Notice of Decision

FILE NO.: Administrative Adjustment of Height Standards,
AAS16-00008

PROJECT NAME: Sunset 7 Apartments

REQUEST: Administrative Adjustment to the Height Standards to increase
the height of the building from the base height of 40 feet to 45'-
10".

Fig. 3. Pedestrian-scale Treatment of Elevation visible from Sunset Way

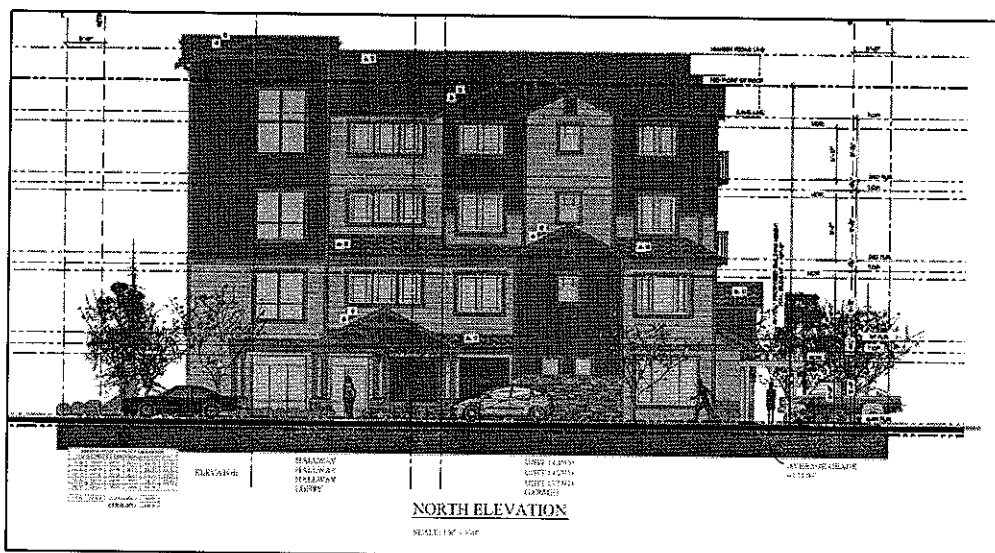
Staff Analysis: Transparent windows and doors are provided for the small lobby, approximately 16 feet wide. A variety of materials are proposed on the ground floor, including stone veneer, concrete masonry units and fiber cement board. Ground floor decorative elements include the double-column wood and stone posts at the front porch and in front of the garage window grills. A workshop occupies the ground floor and is provided with a residential window similar to the ones used on the residential units above (see Fig. 3 below). The elevator and stair tower at the northeast corner of the building is the tallest element along Sunset Way. While elevator shafts are exempted from compliance to the building height limit per IMC 18.07.060.B.4, this criteria still requires that the building is designed to a pedestrian scale. The proposed treatment shows varied materials and textures to break up the height of the tower. Large windows also engage the pedestrian. The dark paint color proposed on the top 2 floors creates a perception of bulk and height. Additional small adjustments to the application of color and architectural details can help reduce the bulk and height of the tower (see condition of approval in the Conclusion).

The exterior design of the elevator and stair tower shall be further refined to architecturally integrate with the rest of the structure and reinforce the pedestrian-scale elements of the building.

- d. Approved street trees are incorporated into the landscape design for the project;

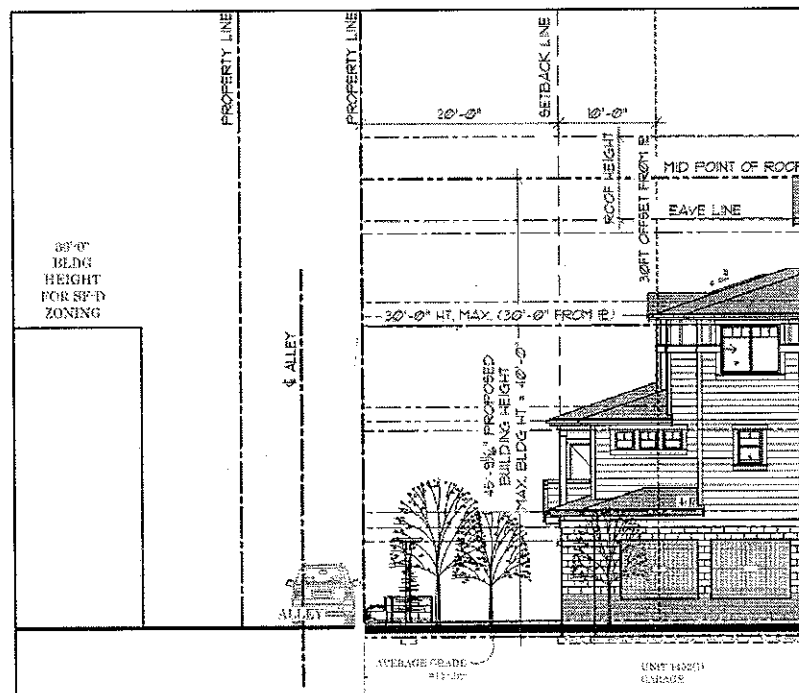
Staff Analysis: Street trees, at 30 feet on-center, are shown on the back side of the sidewalk. The location of the street trees is consistent with the intended design of Sunset Way right-of-way.

WEST ELEVATION

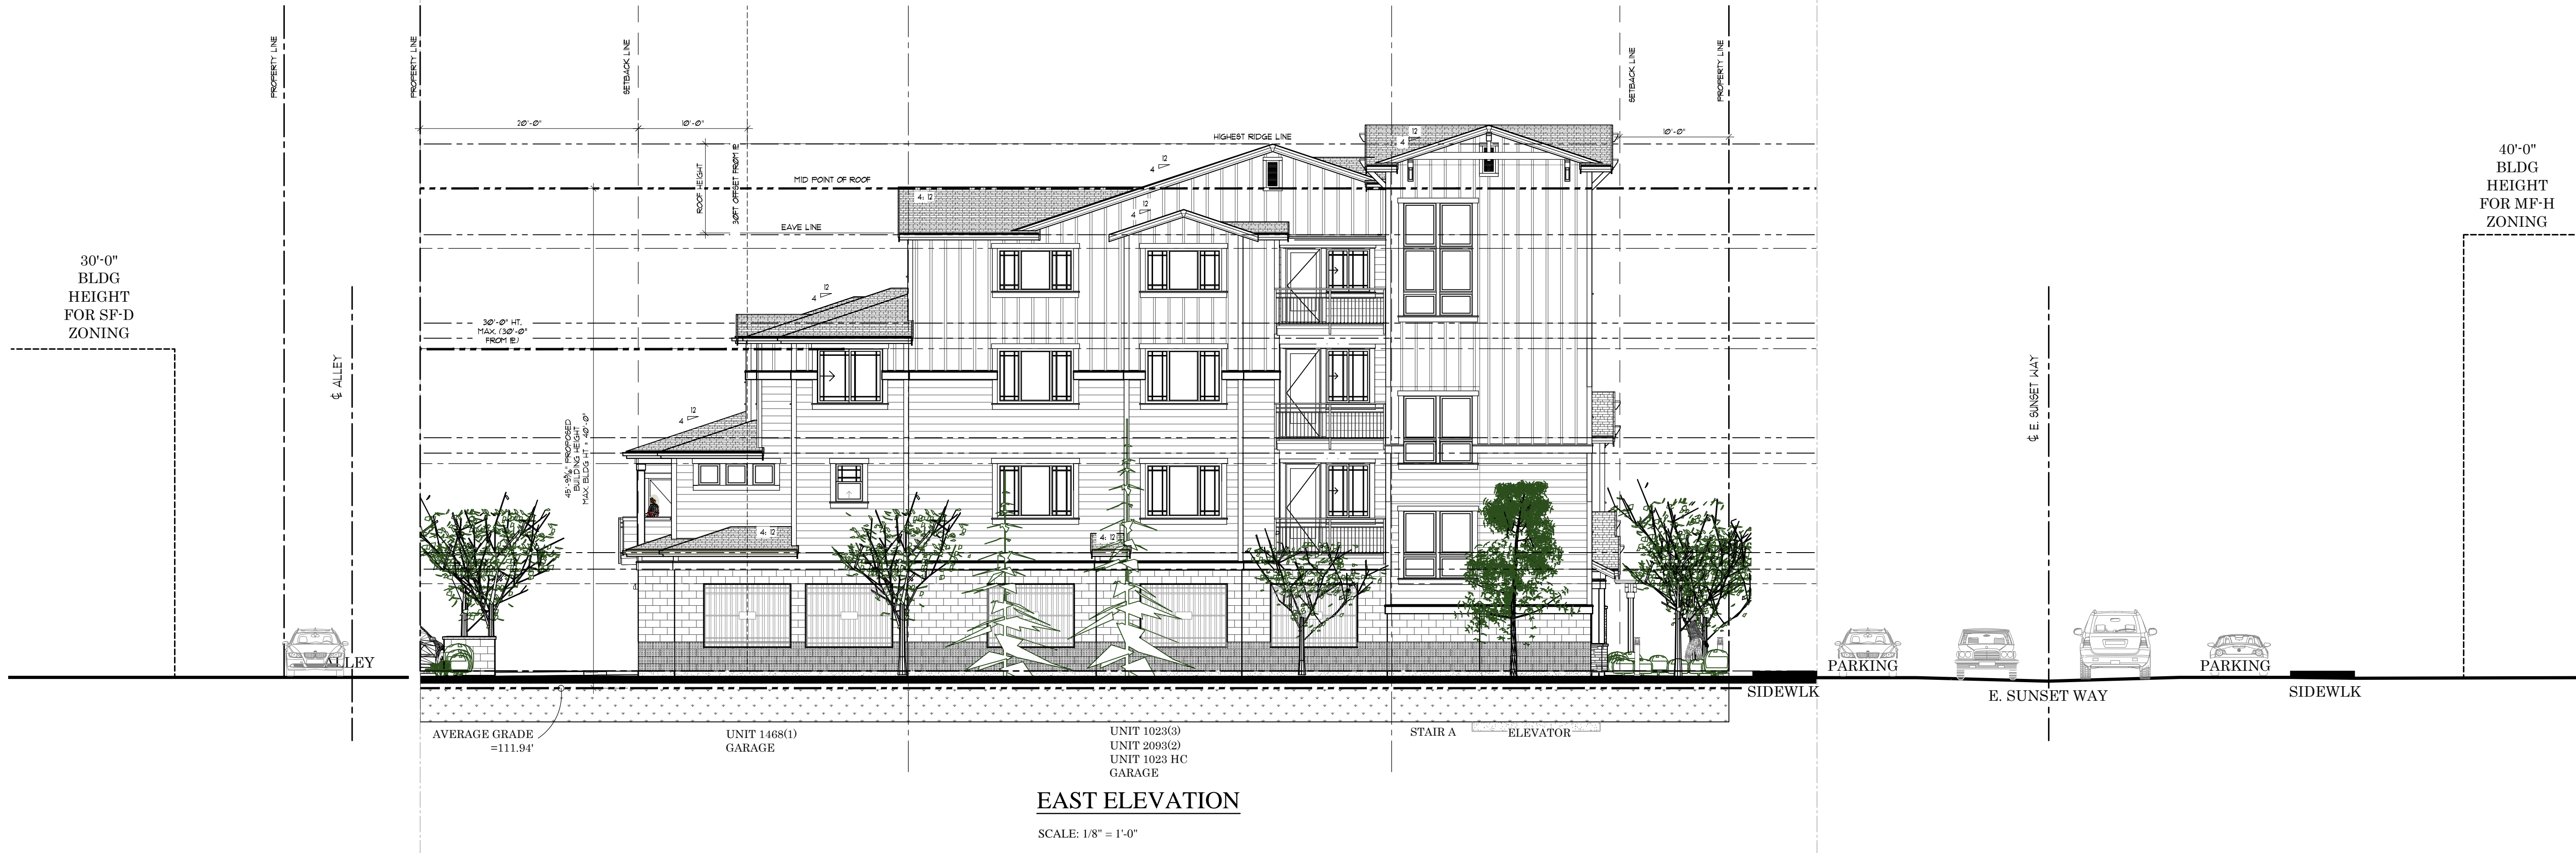
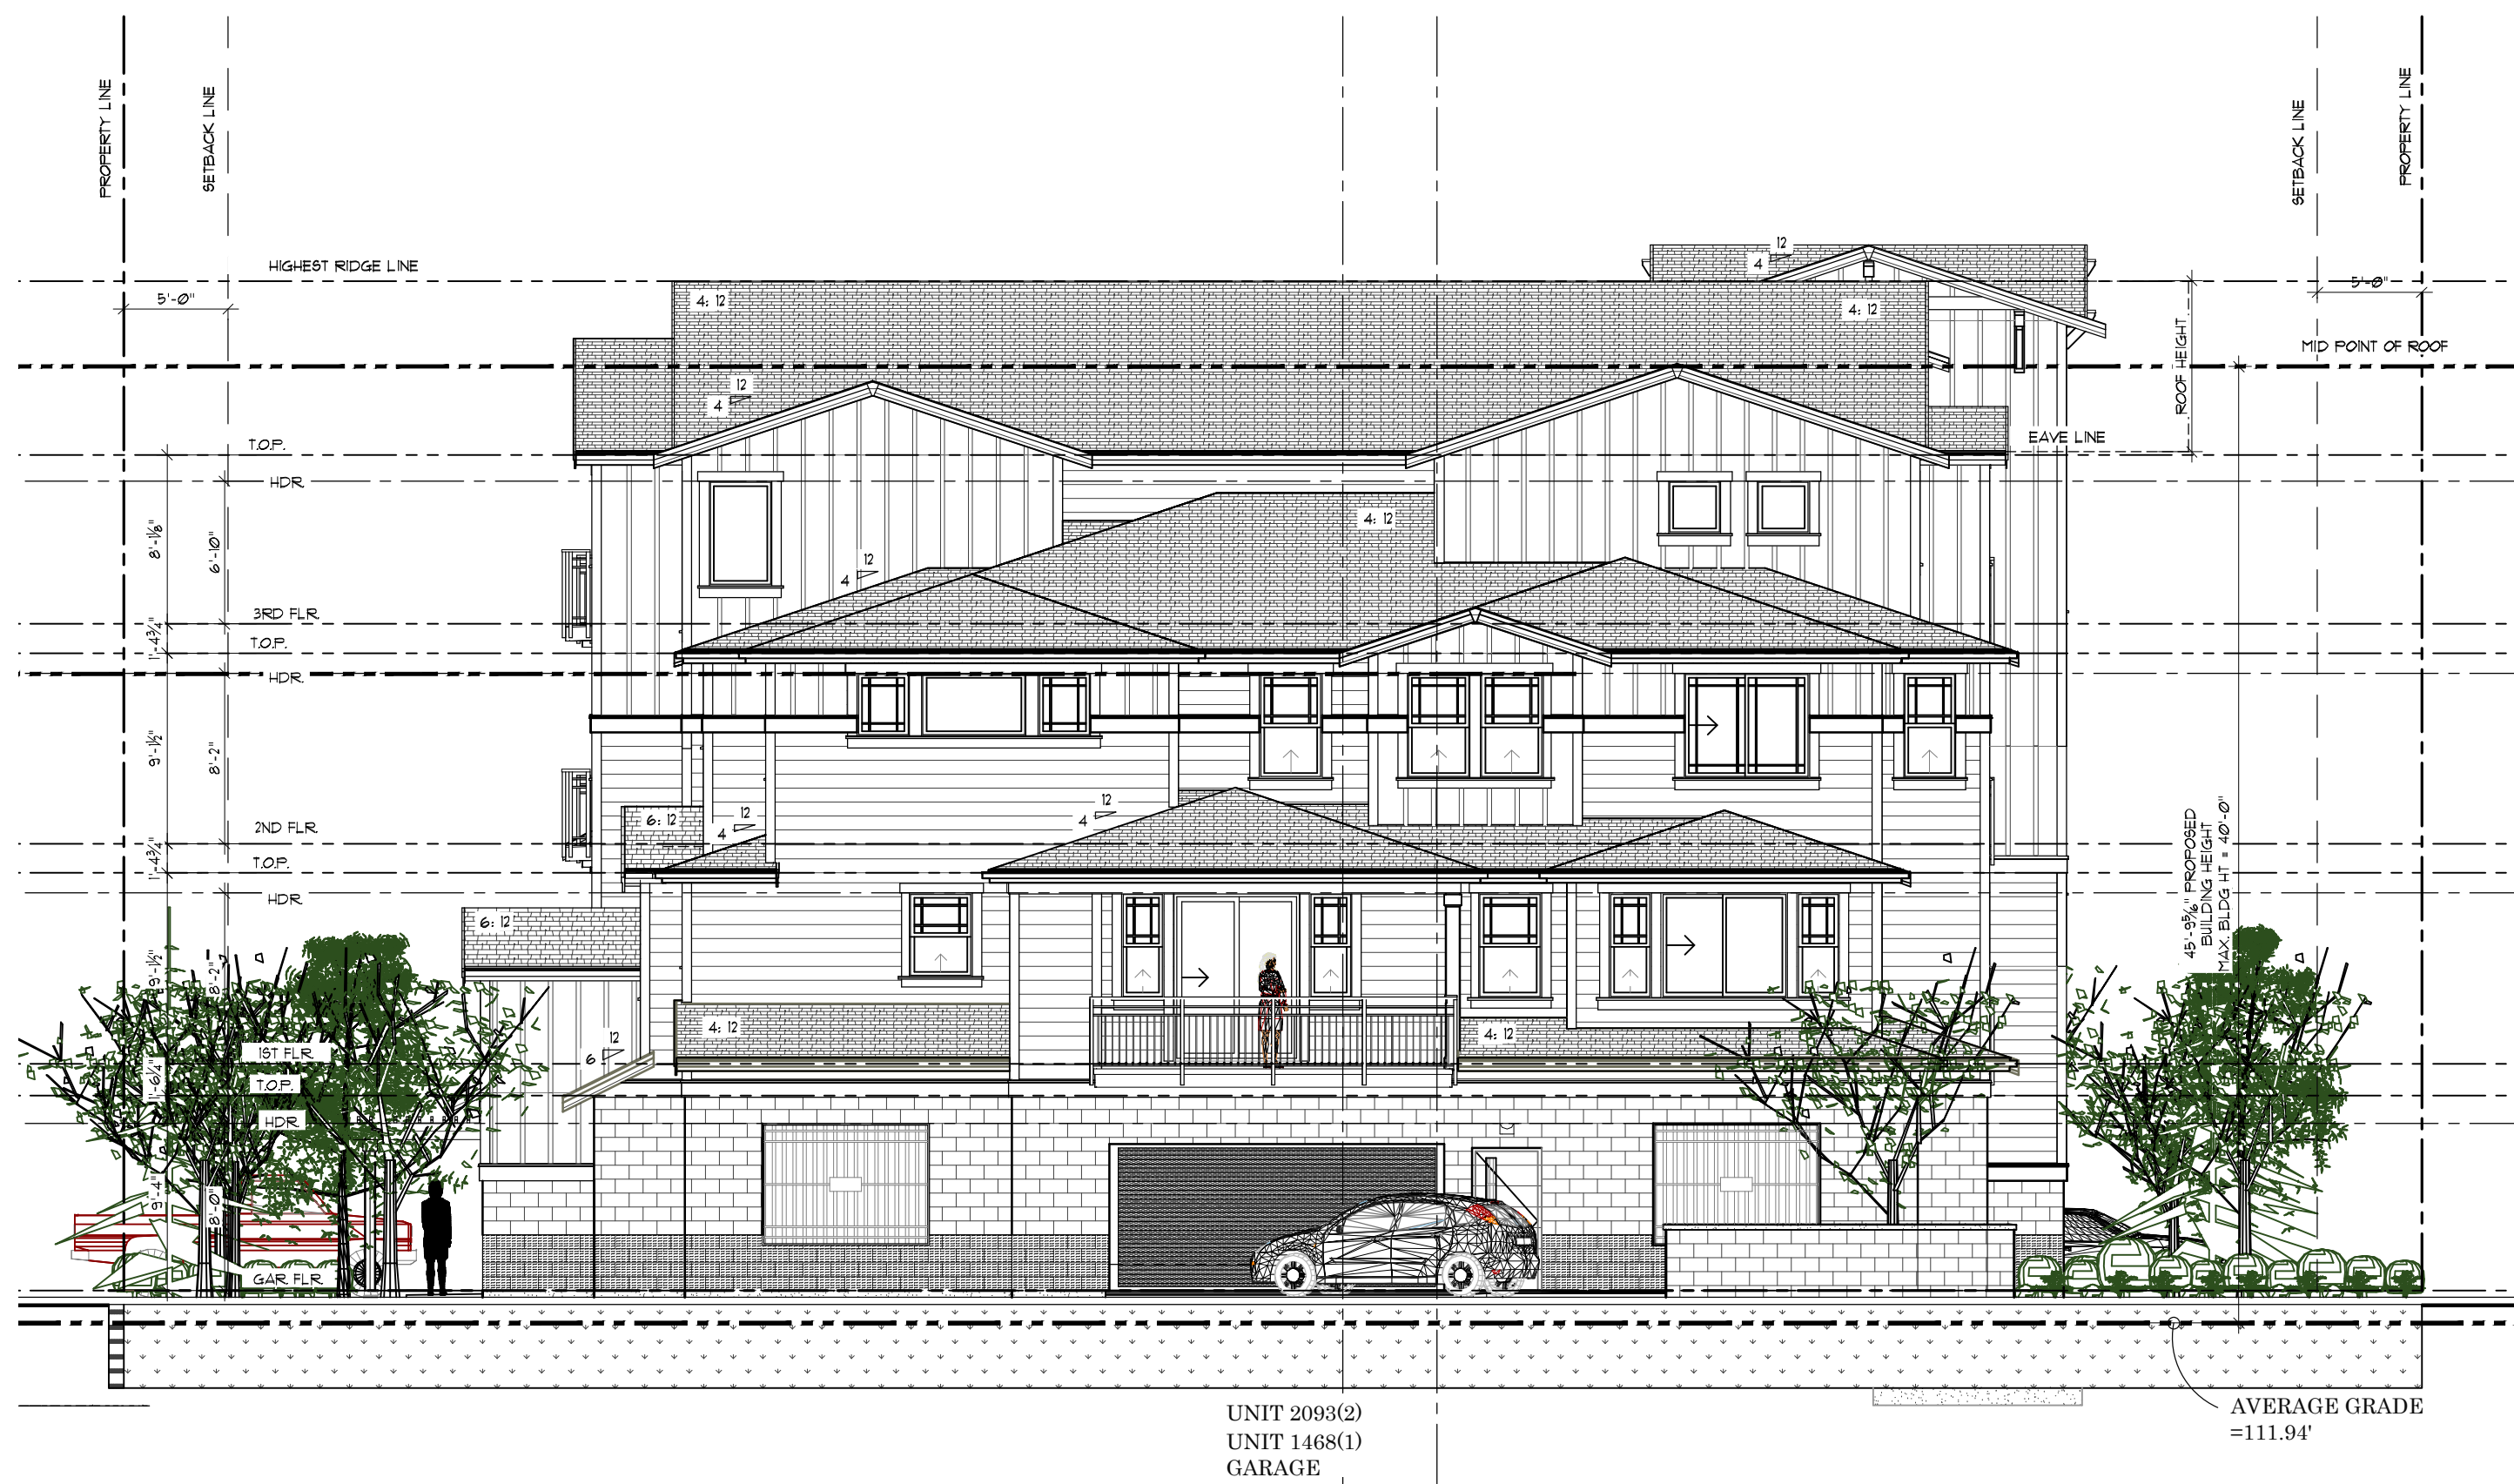
Staff Analysis: The roof is broken up into smaller pitched roofs at various heights. The East and West Elevations show the cascading roof form. The most critical side of the building is the rear, given the single-family zoning across the alley from the project site. This side of the building is well modulated, as shown in Figure 1A and Figure 1B, East Elevation. The Fig. 1B, East Elevation, shows the relationship of the heights for this property and the adjacent properties. The maximum height allowed for adjacent properties is depicted as “boxes” on the drawing. The elevations also show the variety of building materials, including the board and batten and horizontal lap siding that

Staff Analysis: There are no blank walls on the first floor of the street façade that is greater than 20 feet (See elevations on sheets A4.1 and A4.2). The only blank wall is the exterior of the elevator shaft, which is approximately 8 feet wide. East and West elevations have a combination of decorative grillwork for garage openings and trees to mitigate the view of the garage walls from neighboring properties. The emergency stair wall at the west elevation is less than 20 feet. Furthermore, a 6-foot high wood fence is proposed to be erected on the east and west property lines to provide privacy for the adjoining residential neighbors. The south elevation, facing the alley, has no blank walls.

Staff Analysis: The properties across the alley from the project site is zoned at the lower density of SF-D, Single-Family Duplex. The maximum height allowed for the SF-D zoning district is 30 feet. The height of the portion of the building within 30 feet of the rear property line is within the base height limit of 30 feet.
